## AGENDA NOTICE (6/24/2026)

We have completed reviewing the U-Haul Stormwater plans and have several observations and recommendations we outline in the attached technical memo and supporting reference attachments.

MSA has recently been retained by the City of Eagle River to provide Stormwater Management plan review for the planned U-Haul Development along North Bluebird Road and Airport Road located within the City of Eagle River.

**DESIGNER:** DUSTIN VREELAND  
**SURVEYED BY:** OTHERS  
**FILE NO.:** 26-0159  
**ORIGINAL PLAN DATE:** 5/28/2026  
**SCALE:** 1" = 30'  
**SHEET:** C7

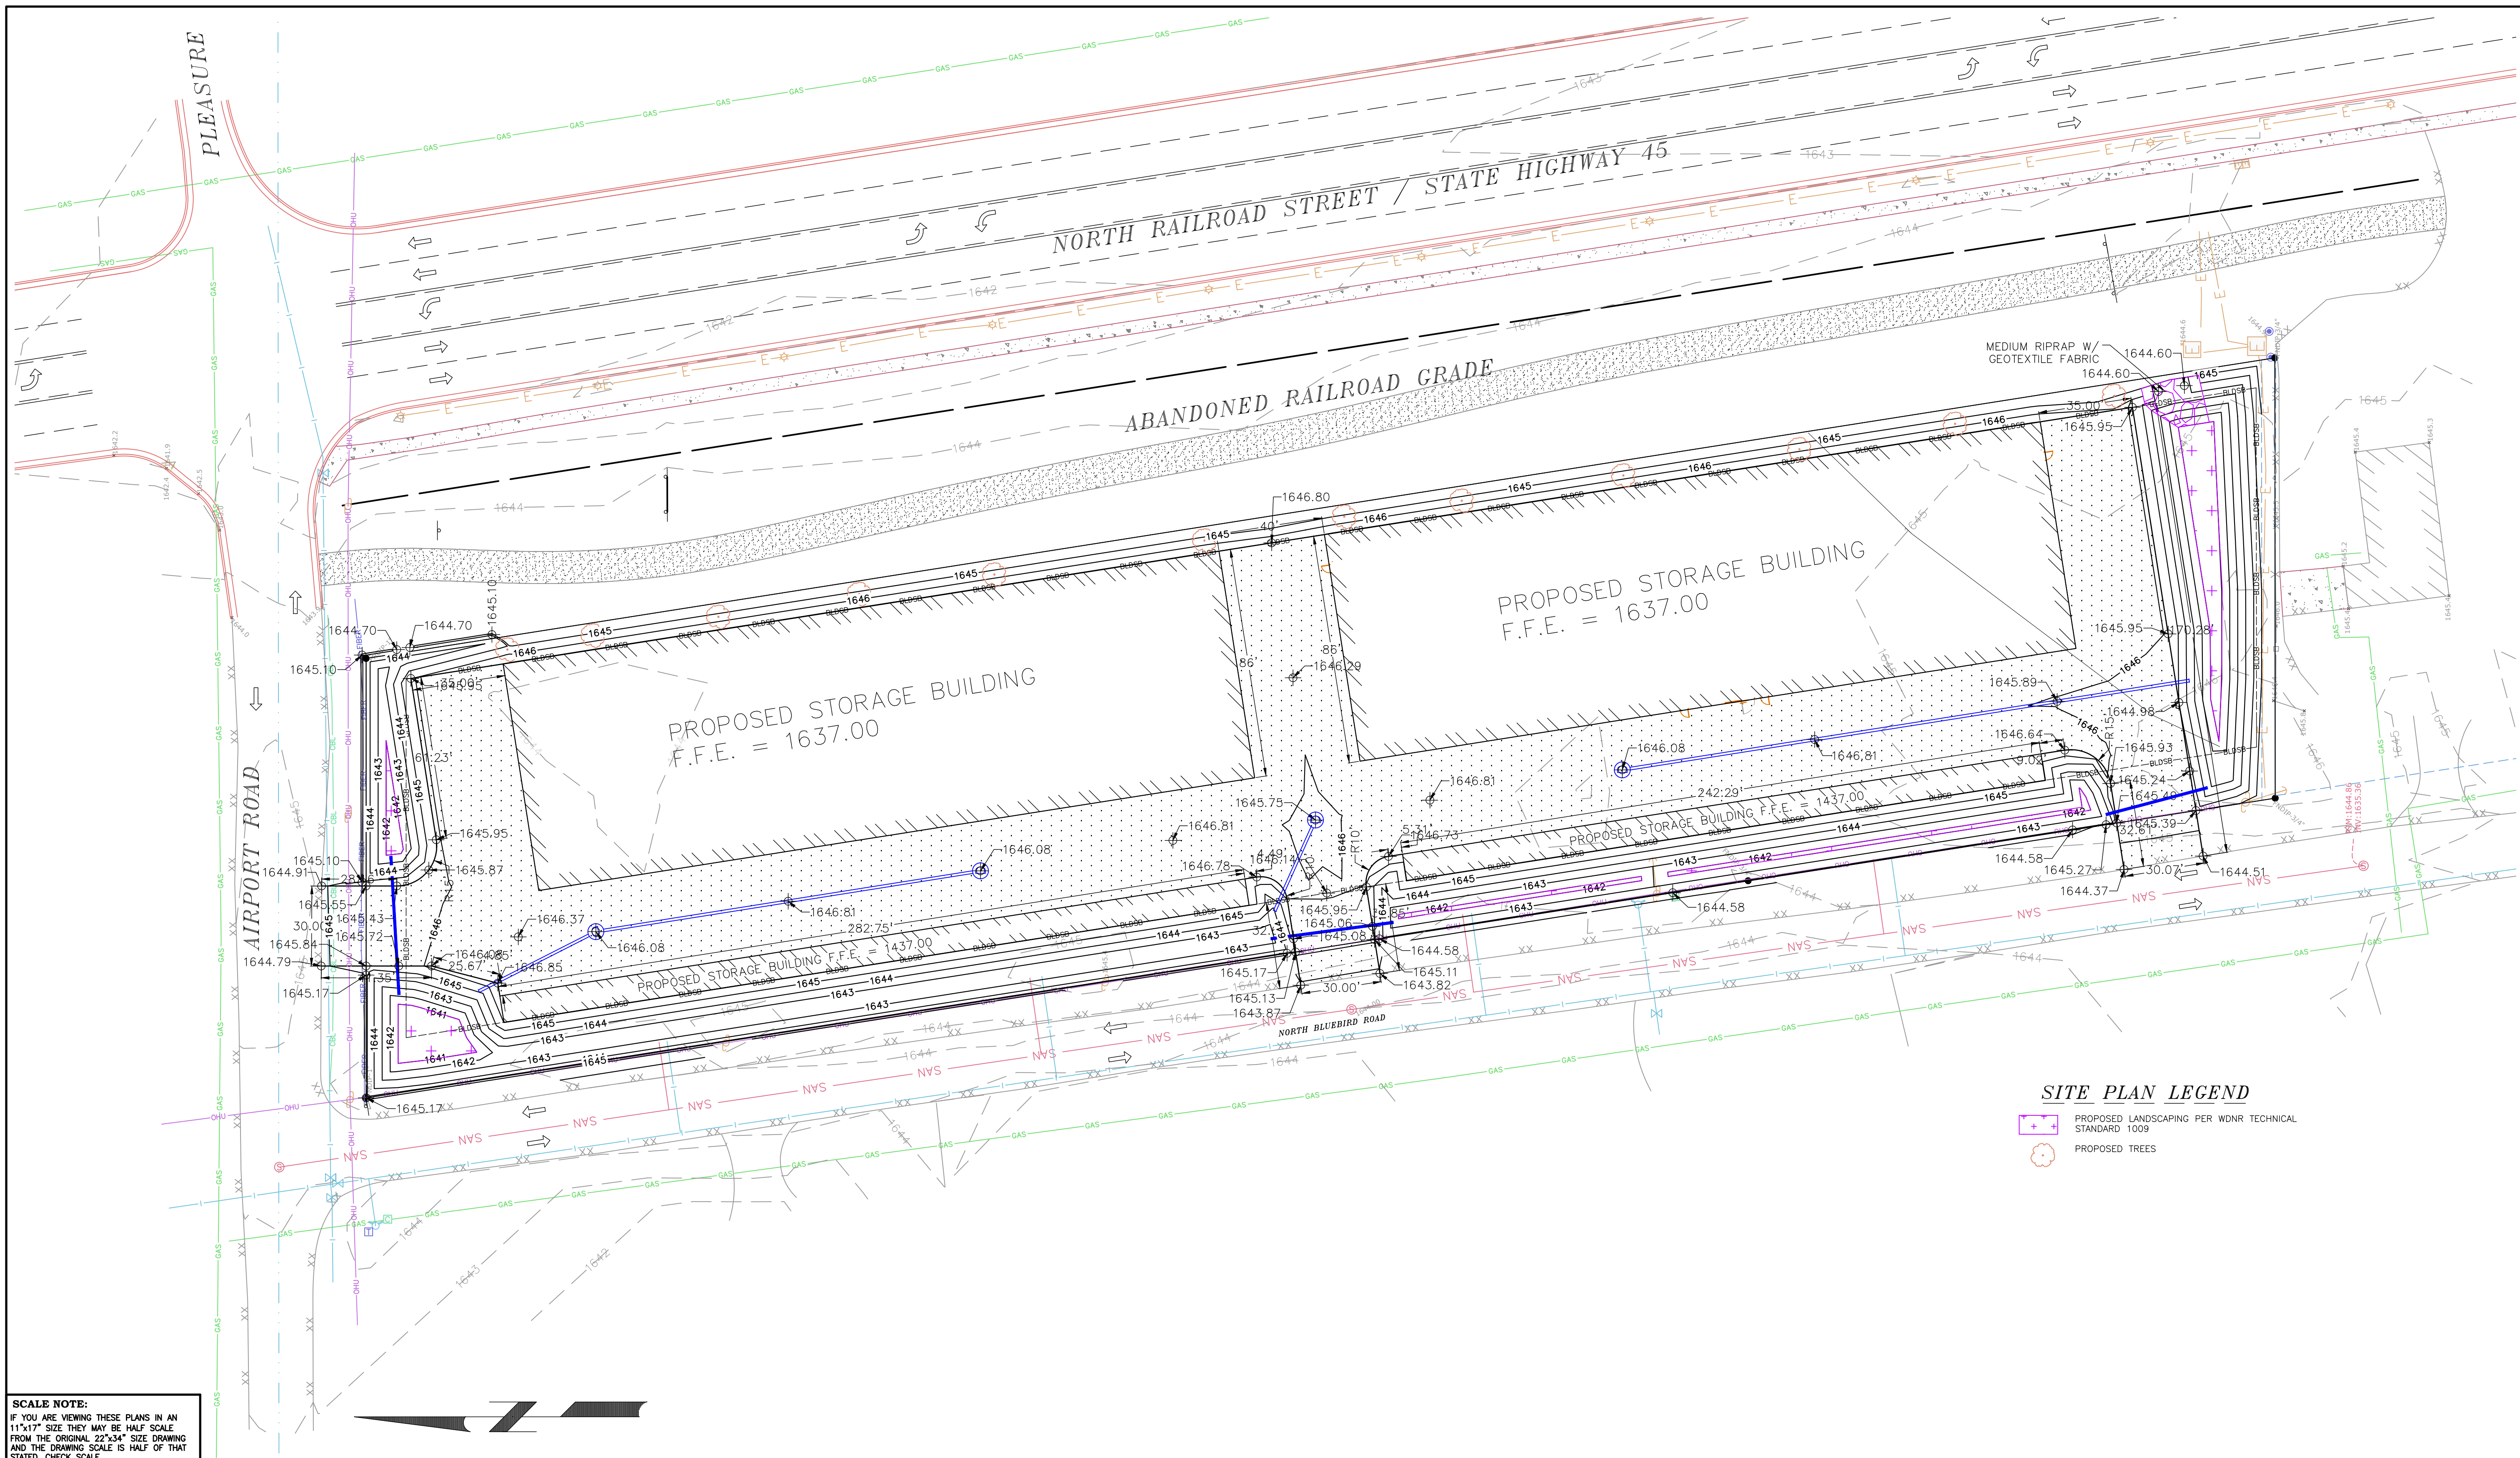
We recommend the biofiltration area at the bottom of the basins be extended to include the sides of the infiltration basins. As well as adding note that the detail applies to all of the infiltration basins.

- It is unclear what mitigation factors are to be used after the infiltration basins overflow as shown in detail on sheet C7 of the proposed stormwater plan and detail.

- It is recommended to add clarity and further address the overflow discharge.
  - Include the location of the emergency overflows on the plans, including dimensions and elevations. Indicate overtopping flow paths or entrance points to municipal systems. Weir velocities shown in HydroCAD do not exceed 2 fps during the 100-yr storm, so vegetated or paved flow paths will be sufficient.

- Update the plans to note that the infiltration basin detail is for all basins, or provide details for all. Include a separate detail for basins P3 and P4, to show the shared overflow spillway between.
